Clonburris T1

Street Hierarchy, Design & Layout Submission

For Proposed Residential Development
Clonburris T1, Co. Dublin

Compliance Submission in Accordance with
Planning Condition no. 2

Plan of Street 12 / Drawing Ref: CLB-1-00-SW-ZZ-DR-CWO-AR-1000

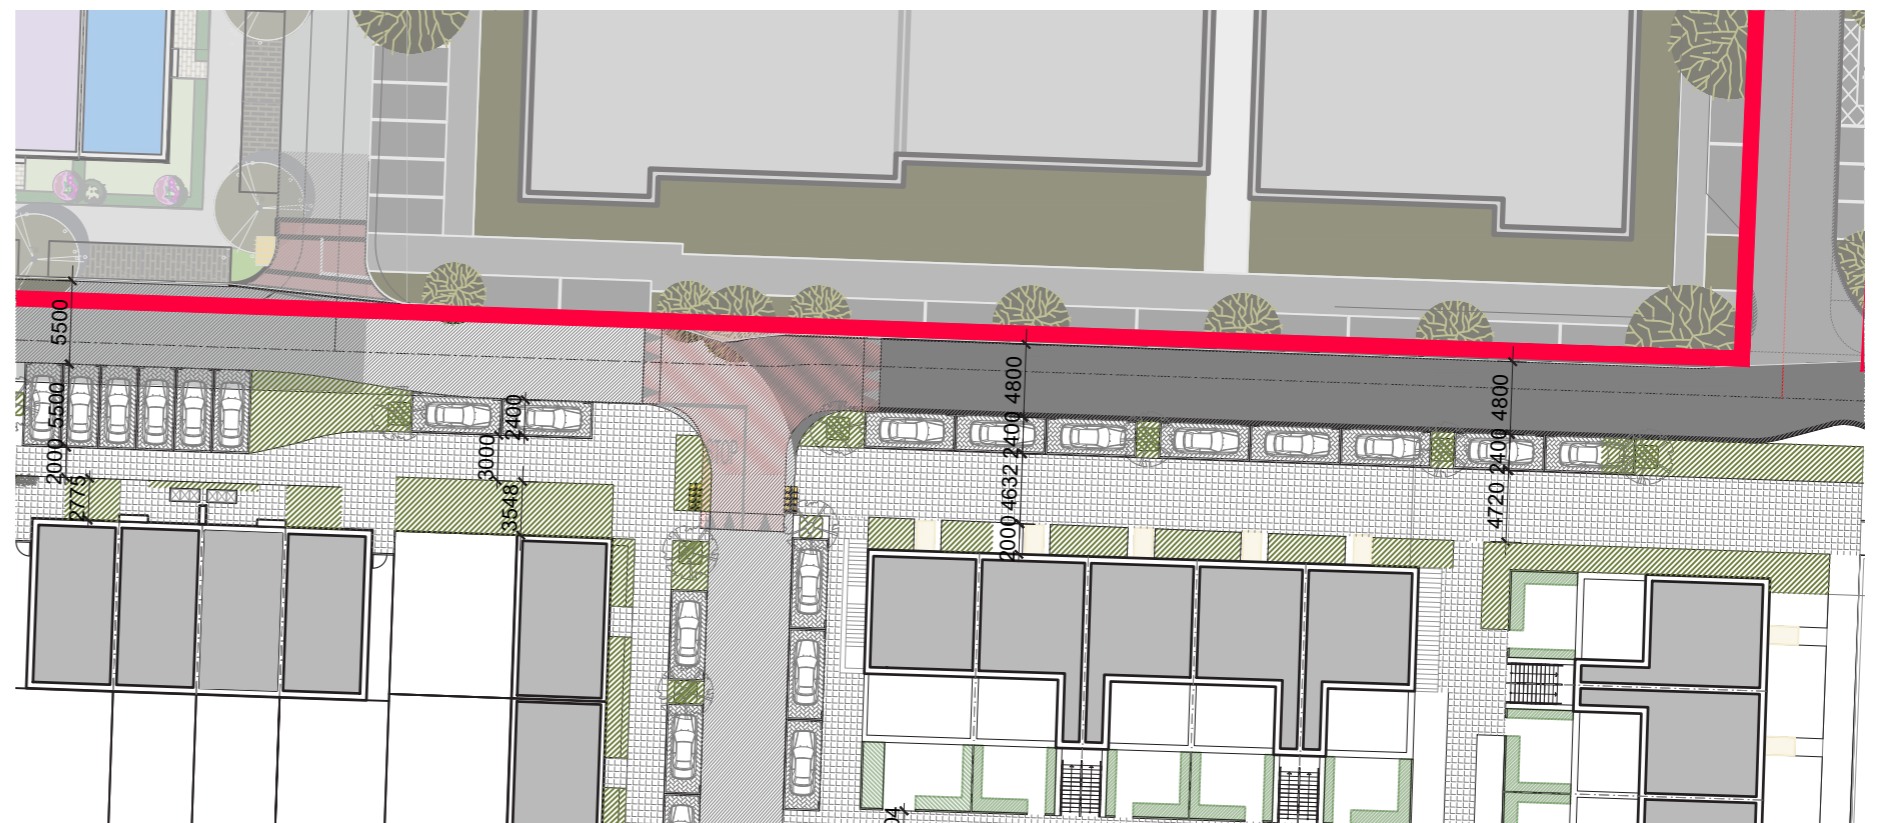
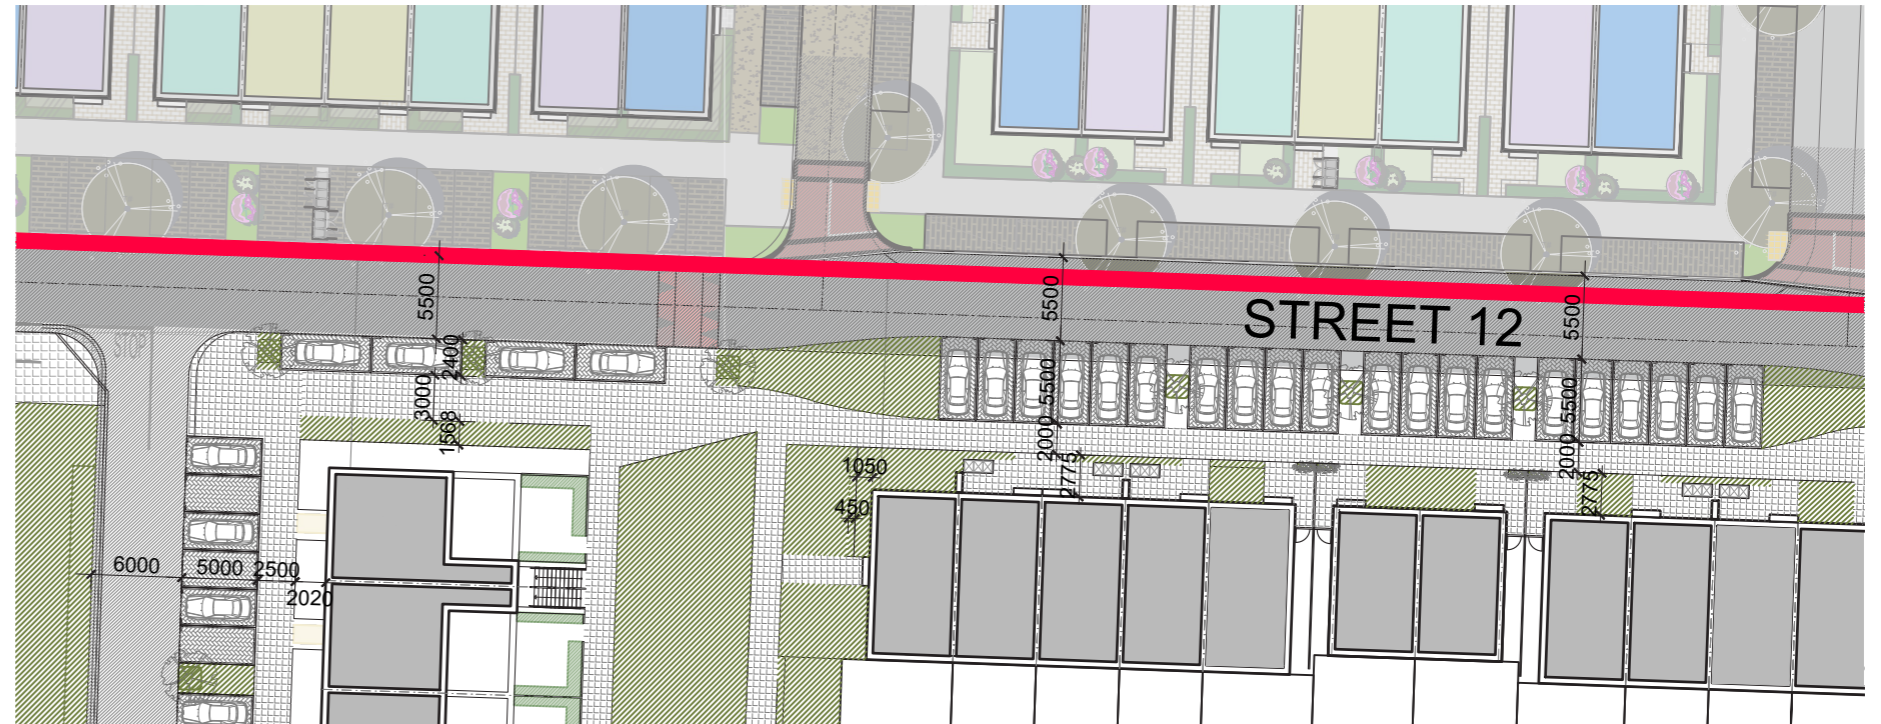
2 (m) Street 12: This street is situated adjacent to a future development site. The overall width is currently unknown. The street shall be redesigned in general accordance with either Figure 2.2.6 Indicative Local Street A or B. i.e.:

- The street shall have a carriageway width of no less than 5 meters and no more than 6 meters; 6m shall be provided for reversing if perpendicular parking is proposed

- Perpendicular parking bays shall be a minimum of 5m deep and parallel shall be a minimum of 2.4m.
 - At any point along the road, perpendicular parking shall be provided on one side only;

- A footpath width of between 2.5 and 4 meters shall be provided;
 - Privacy strips/short gardens that range from 1 to 3 metres in depth shall be provided

- Street trees shall be provided in accordance with Condition 7
- OR
- The street shall have a carriageway width of no less than 5 meters and no more than 5.5 meters;

- Only parallel parking shall be provided and it shall be a minimum of 2.4m deep.
 - A footpath width of between 2.5 and 4 meters shall be provided;
 - Privacy strips/short gardens that range from 1 to 3 metres in depth shall be provided

Street 12 has been designed in accordance with Figure 2.2.6 'Indicative Local Street A' and with reference to the emerging proposed design for the opposite side of the street.

- The street has a carriageway width of 5.5 meters;
- Perpendicular parking bays are a minimum of 5.5m deep to allow for reversing.
- Perpendicular parking is provided on one side of the road only;
- A footpath width ranging from 2 to 3 meters has been provided;
- Privacy strips of 1.5 to 2.7 meters have been provided;
- Street trees have been provided in accordance with Condition 7.

Plan of Canal Road / Drawing Ref: CLB-1-00-SW-ZZ-DR-CWO-AR-1000

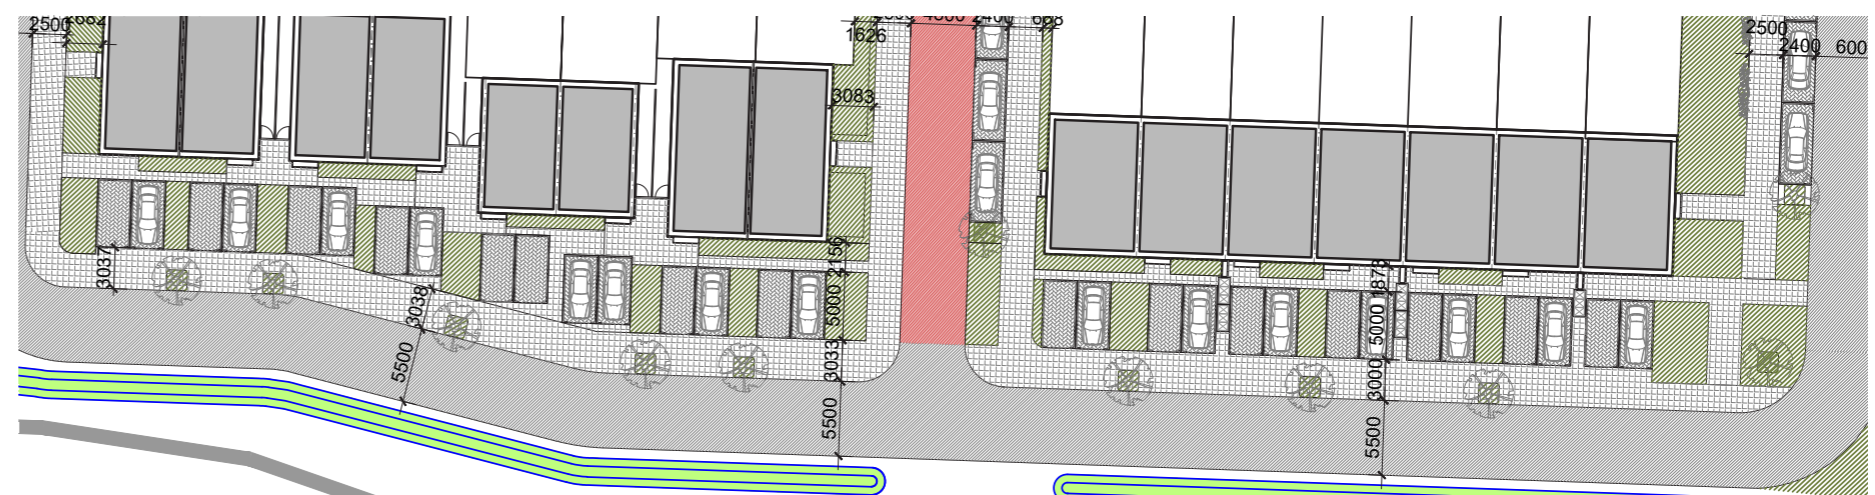
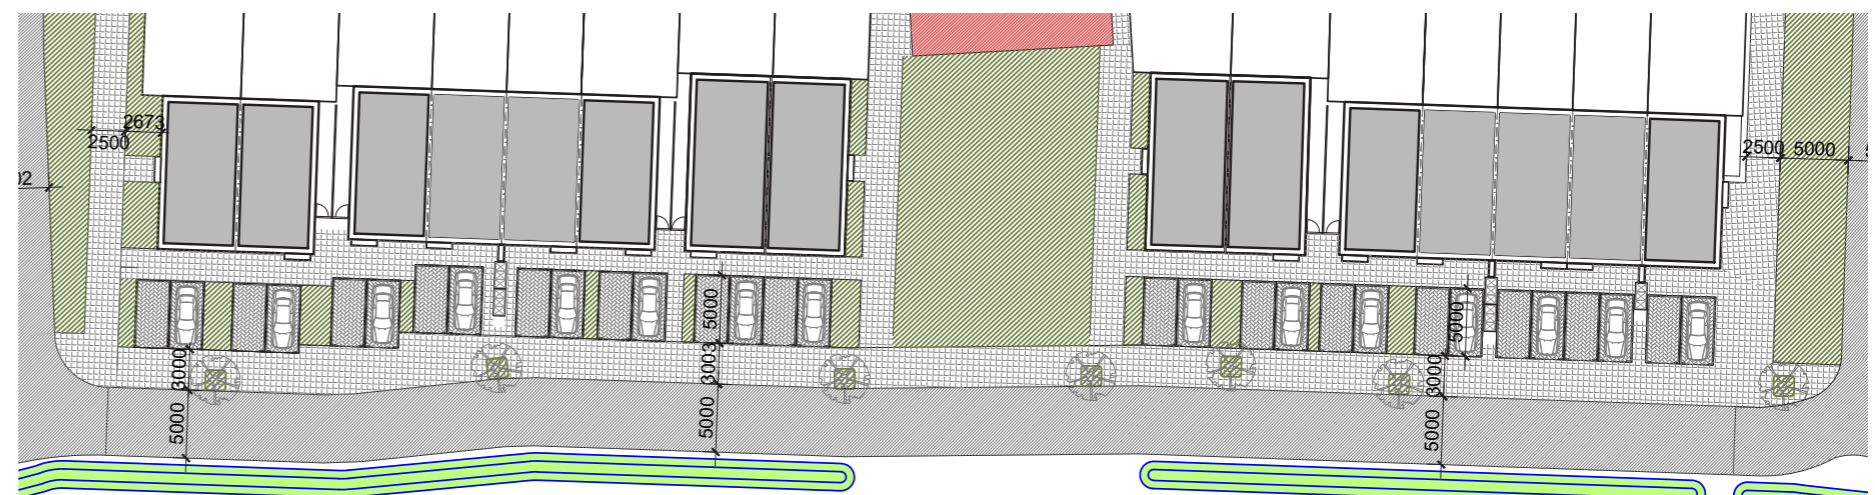
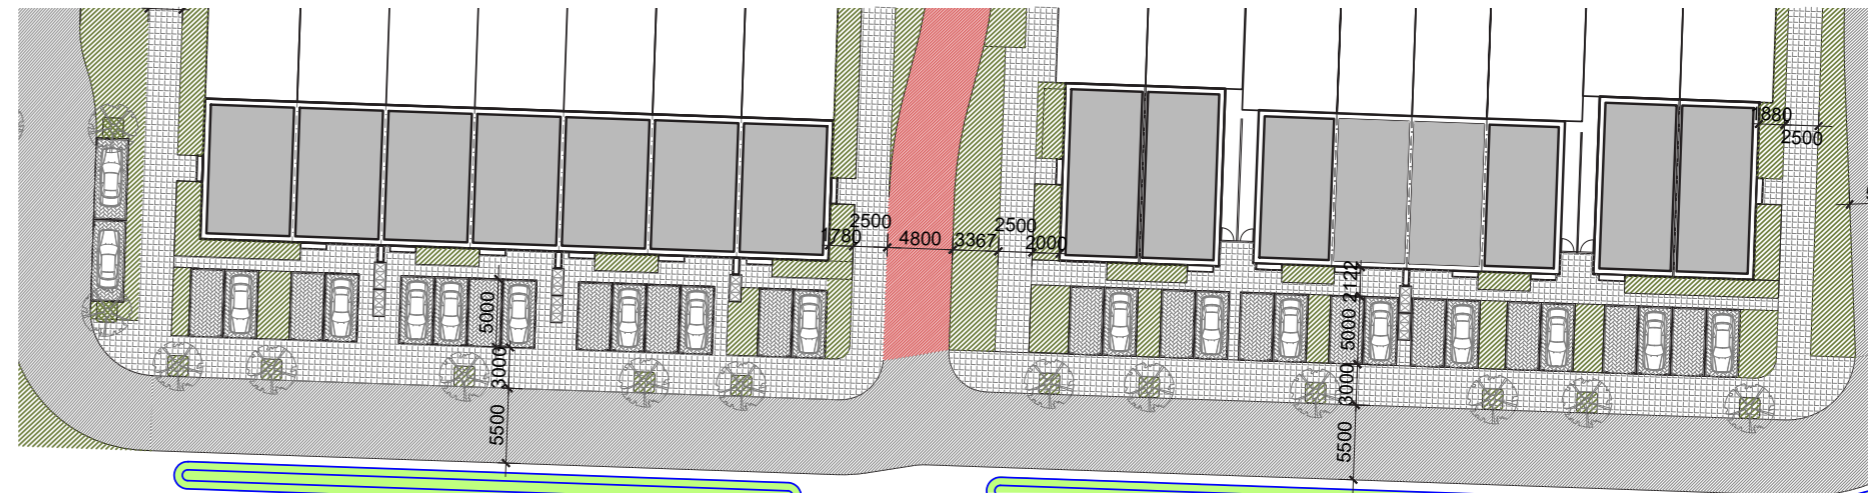
2 (n) Canal Road: This shall be redesigned in general accordance with Figure 2.2.6 Indicative Local Street A. The following detail shall be provided:

- The street shall have a carriageway width of no less than 5 meters and no more than 6 meters; 6m shall be provided for reversing if perpendicular parking is proposed
- Perpendicular parking bays shall be a minimum of 5m deep and parallel shall be a minimum of 2.4m.
- At any point along the road, perpendicular parking shall be provided on one side only;
- A footpath width of between 2.5 and 4 meters shall be provided;
- Privacy strips/short gardens that range from 1 to 3 metres in depth shall be provided
- Street trees shall be provided in accordance with Condition 7
- No car parking shall be located adjacent to the canal park.

Canal Road has been designed in accordance with Figure 2.2.6 'Indicative Local Street A'.

- The street has a carriageway width of between 5m and 5.5m has been provided.
- Perpendicular parking bays are a minimum of 5m deep.
- Perpendicular on-curtilage parking is provided on one side of the road only;
- A footpath width of 3 meters has been provided throughout;
- Privacy strips of 1.6 to 2.1 meters have been provided;
- Street trees have been provided in accordance with Condition 7;
- No car parking has been located adjacent to the canal park.
